**CITY OF LOVELAND
STORM DRAINAGE CRITERIA
(ADDENDUM TO THE
URBAN STORM DRAINAGE CRITERIA MANUALS
VOLUMES 1, 2, AND 3)**

Prepared by: RESPEC, Inc.

Date: March 20, 2020

Figure 7-16

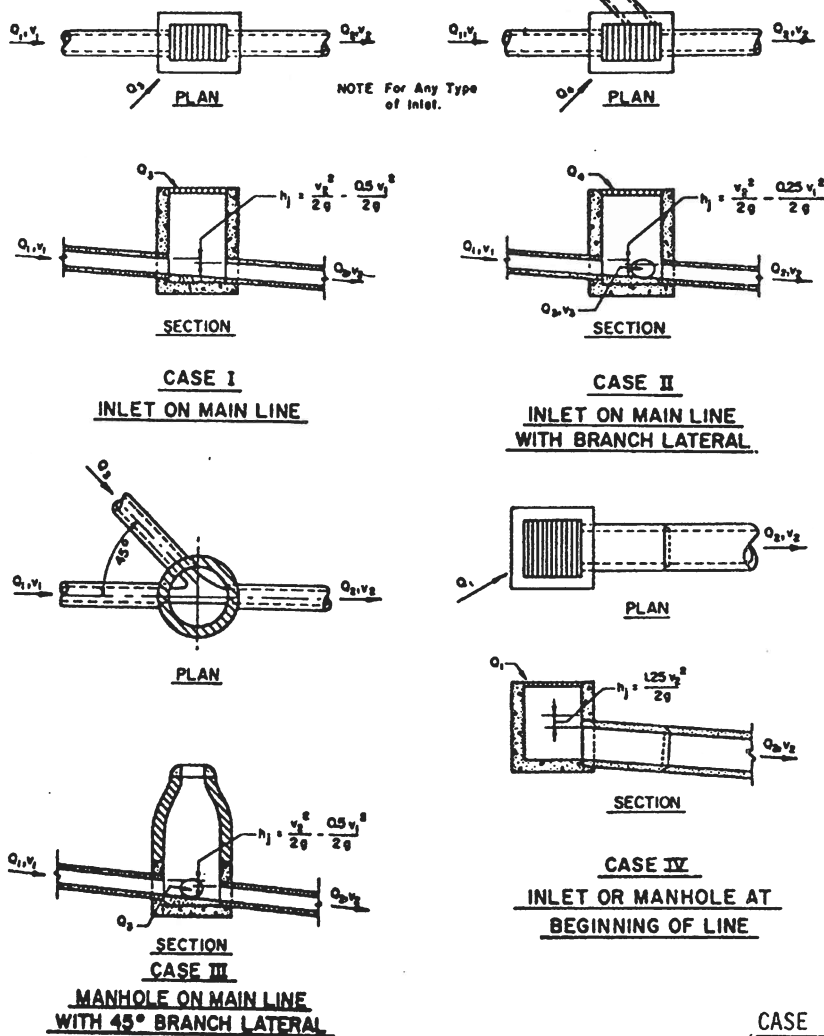
Change K_e = entrance loss coefficient between 0.2 to 0.5
To K_e = entrance loss coefficient from Figure 7-16

Add Figure 7-16

Change K_b = bend loss coefficient
To K_b = bend loss coefficient from Figure 7-16
